From: Andrew Leon <andrew.leon@mercerisland.gov>
Sent time: 2022/10/06 10:40:06 AM
To: Jackie <jackie@mediciarchitects.com>
Cc: Schuyler Tutt <schuyler@mediciarchitects.com>; Ryan Harriman
Subject: RE: PRE22-038: 2430 74th Ave SE
Attachments: image001.png

From: Jackie <jackie@mediciarchitects.com>
Sent: Wednesday, October 5, 2022 2:54 PM
To: Andrew Leon <andrew.leon@mercerisland.gov>
Cc: Schuyler Tutt <schuyler@mediciarchitects.com>
Subject: PRE22-038: 2430 74th Ave SE

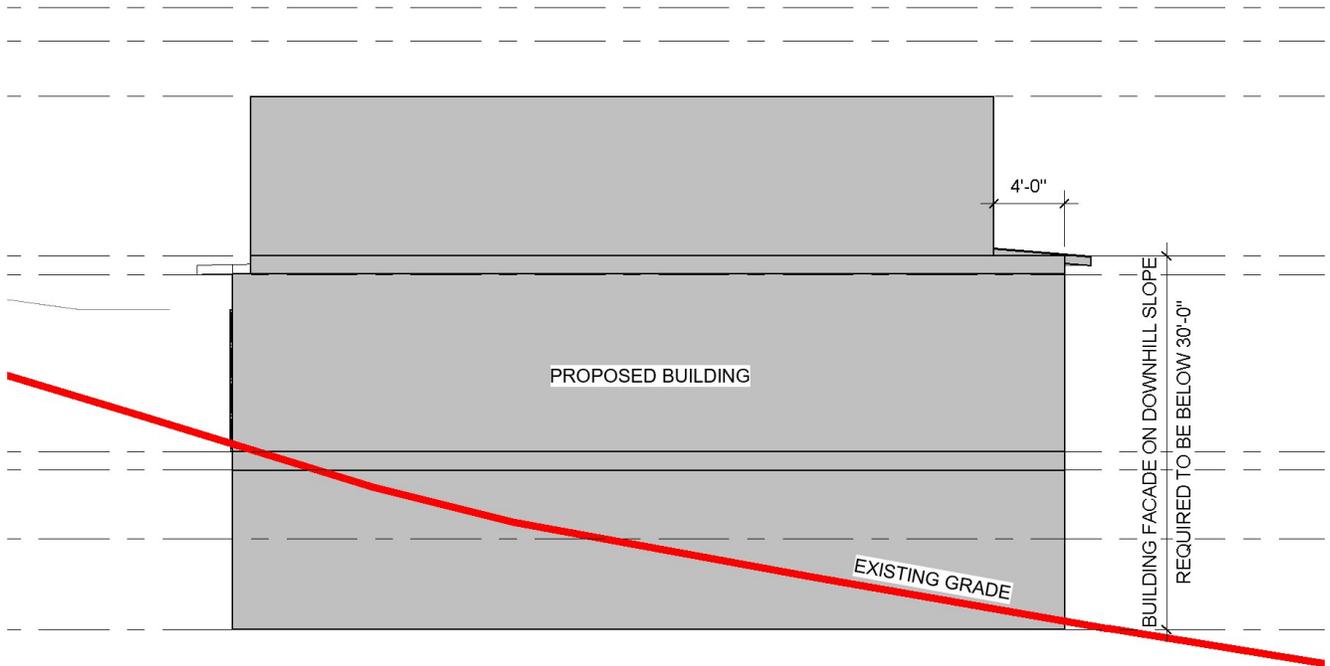
Thank you for the response. At what distance would a façade be considered separate? If the furthest downhill exterior wall supports a roof then should it not be considered its own façade and separate from subsequent stepping back?
The code section seems to speak only of a roof, not the highest roof of the overall building.

We appreciate a second look at this, as our intent is to lessen the bulk of the building on the downhill side of the slope while still maintaining reasonable interior heights and presence at the street side of the lot.

This is Jackie with Medici Architects, and I just had a follow up question regarding the building height requirements on the downhill side of the building. Section 19.02.020.E.2 requires that the maximum building façade height on the downhill side of a sloping lot shall not exceed 30 feet in height. The building façade height shall be measured from the existing grade or finished grade, whichever is lower, at the furthest downhill extent of the proposed building, to the top of the exterior wall façade supporting the roof framing, rafters, trusses, etc.

We are proposing a setback of the building in order to follow the topography of the site and would like to confirm that our intent is correct. Below is a diagram depicting the setback and conforming façade height.

There is no distance at which an upper floor can be set back and be considered a different façade from the lower floors. In essence, the highest point of the wall on the downhill side of the house would need to be less than 30 feet above the bottom of the wall at its lowest point, where the top of the wall is measured from the bottom of the roof framing and the bottom of the wall is measured at the existing or finished grade, whichever is lower. This would apply regardless of how far the upper floors are set back from the lower floors.

MICC 19.16.010 defines façade as any exterior wall of a structure, including projections from and attachments to the wall. Projections and attachments include balconies, decks, porches, chimneys, unenclosed corridors, and similar projections. MICC 19.02.020(E)(2) does not contemplate multiple building facades or exterior wall facades on the downhill side of a sloping lot, only the maximum building façade height as a single exterior wall supporting the roof. As such, the downhill façade for the diagram you provided in your email would include all three floors of the house.
